# Applicable Urban Design Priorities Project Should Achieve

## UDPRP Review Summary 02.20.15

PROJECT: The Canyon Phase I Retail

### The Canyon - Retail Phase I

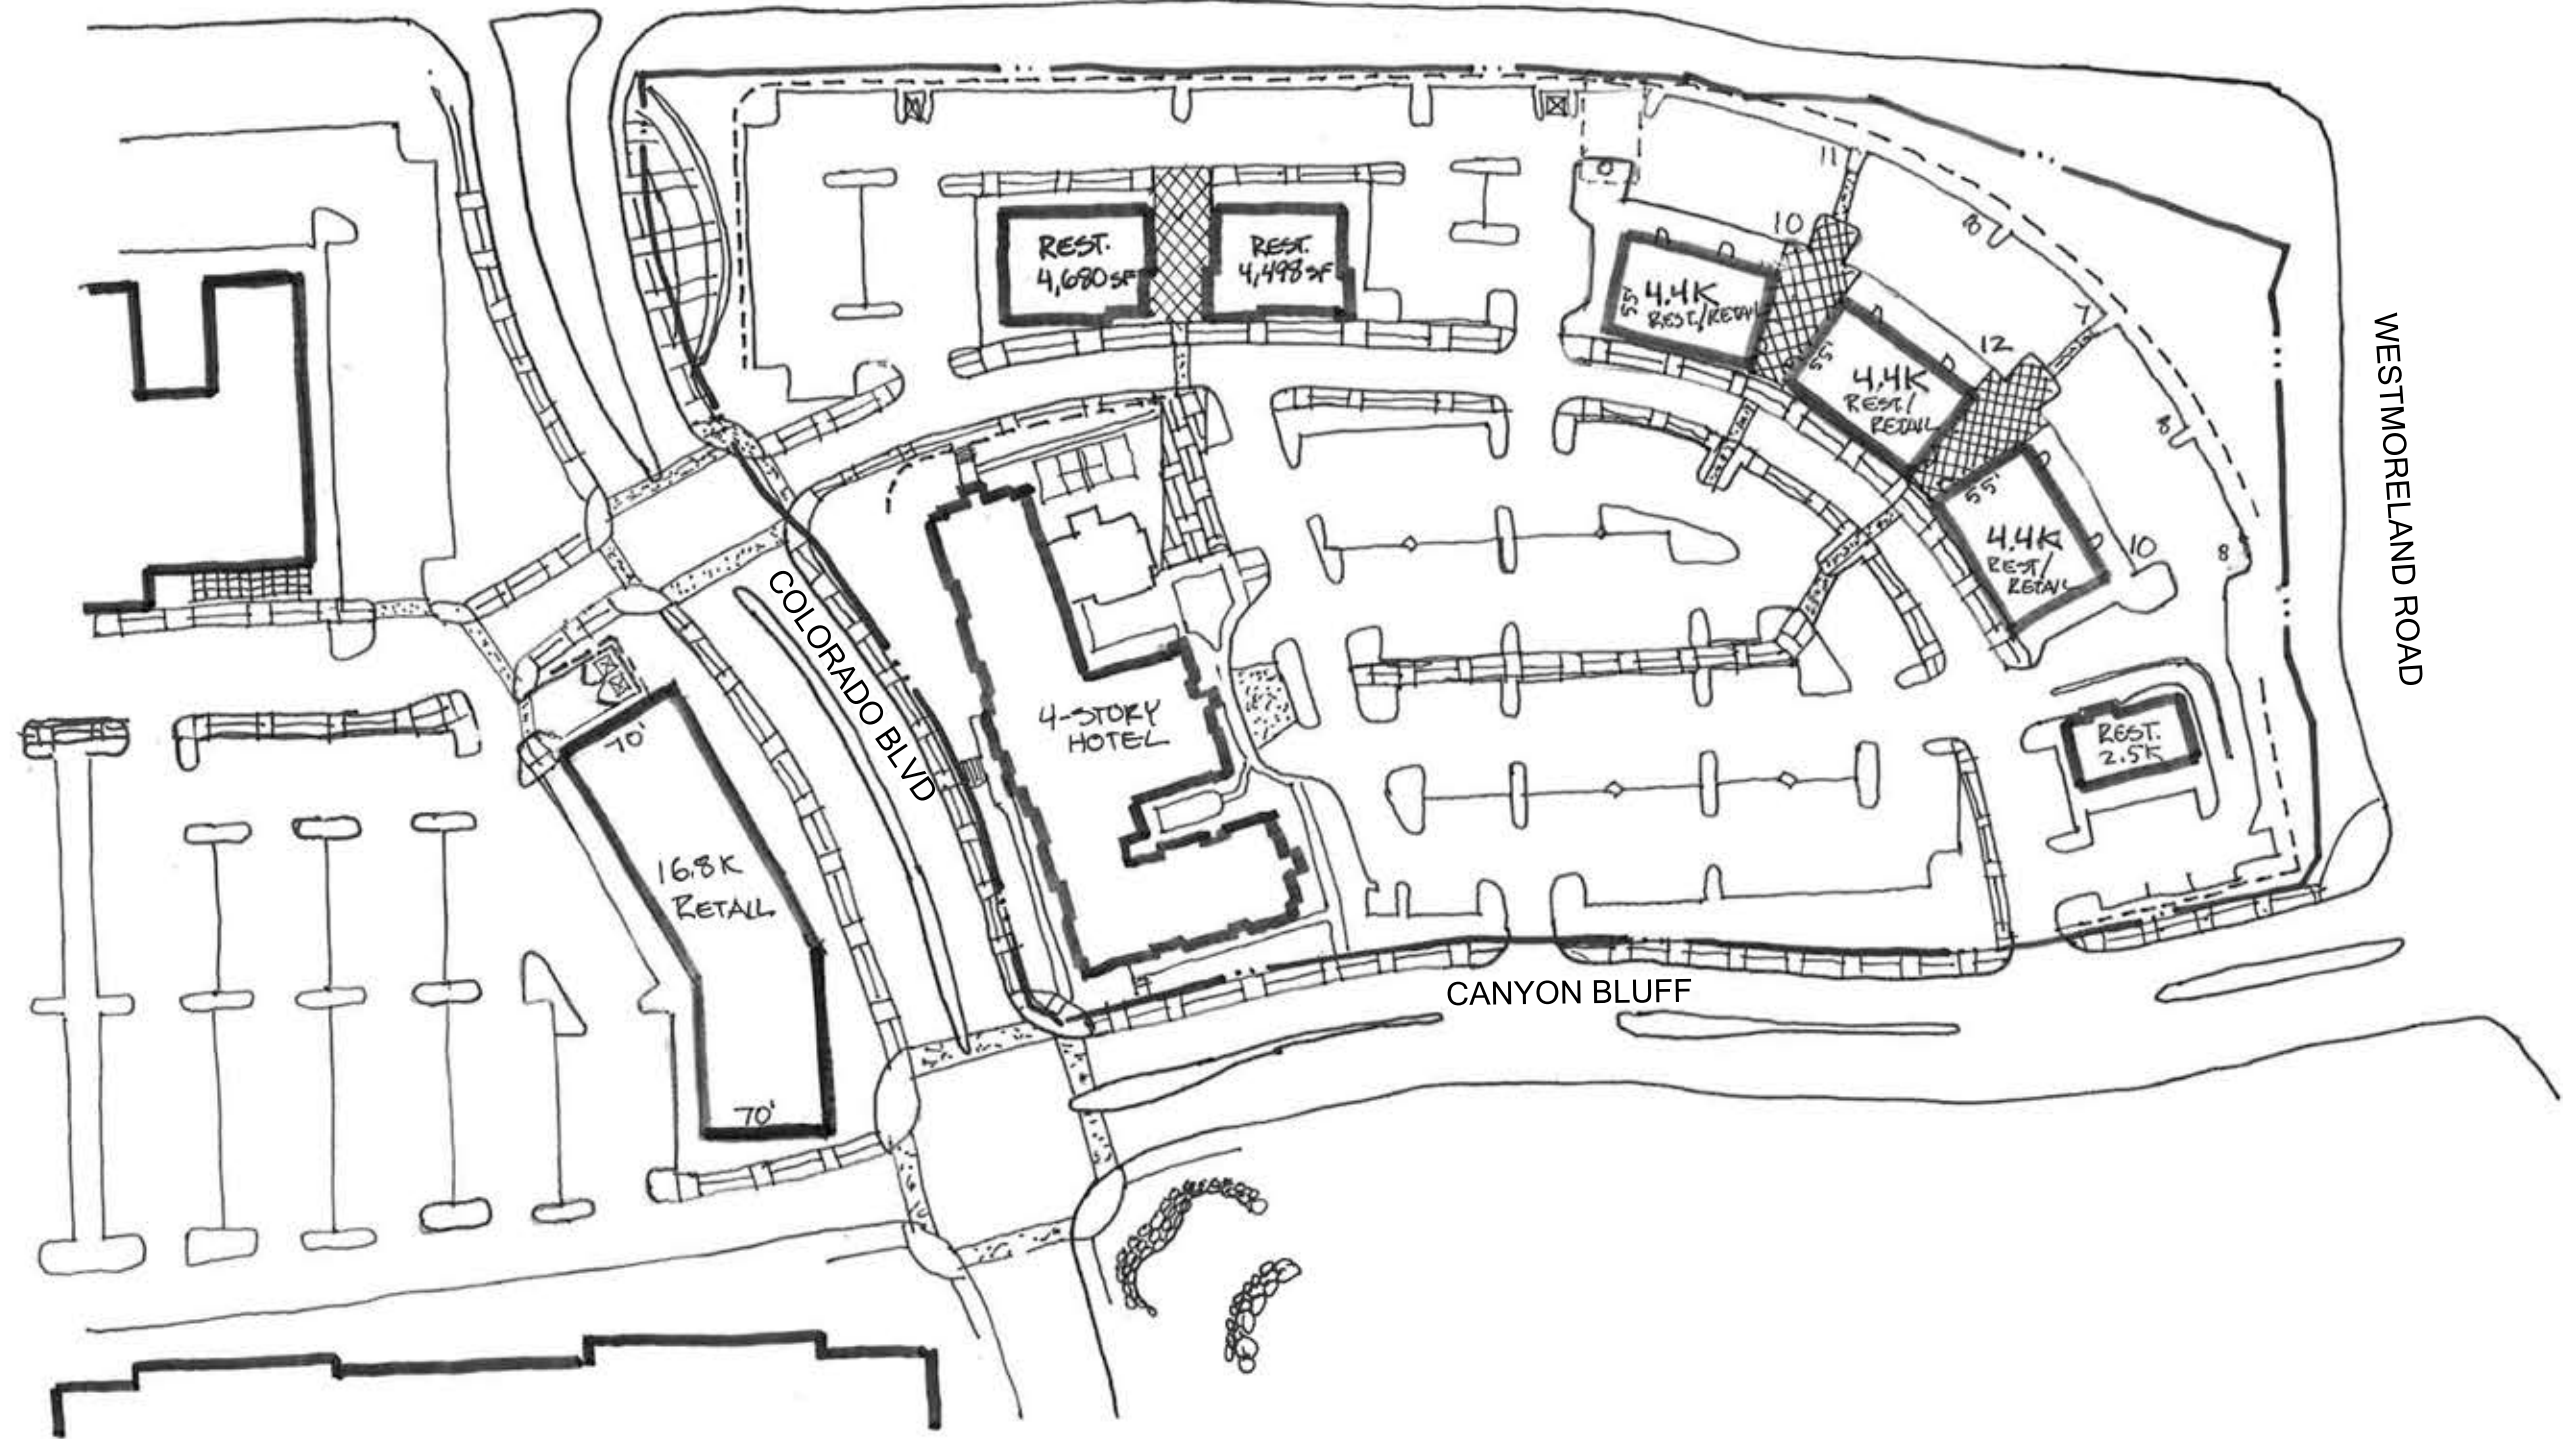
- [1] The panel supports the general character of the overall site strategy for the Canyon, but expresses concern that the character of the overall vision is not carried into the planning of the Phase I retail block.

- [3] The panel expresses concern regarding the overly suburban character of the block noting that typically suburban elements can and should be organized around urban principles.

- [4] The panel strongly recommends an alternative site arrangement that spatially integrates the hotel with the other proposed uses, especially the food and beverage components.

- [5] The panel strongly recommends the integration of iswm measures and principles into the plan, with particular attention given to the design of the parking fields.

- [6] The panel recommends that a revised site plan responding to the panel recommendations be presented for a follow-up review.
- [7] A meeting to review the overall development plan is recommended to identify development blocks and associated design expectations in the future.
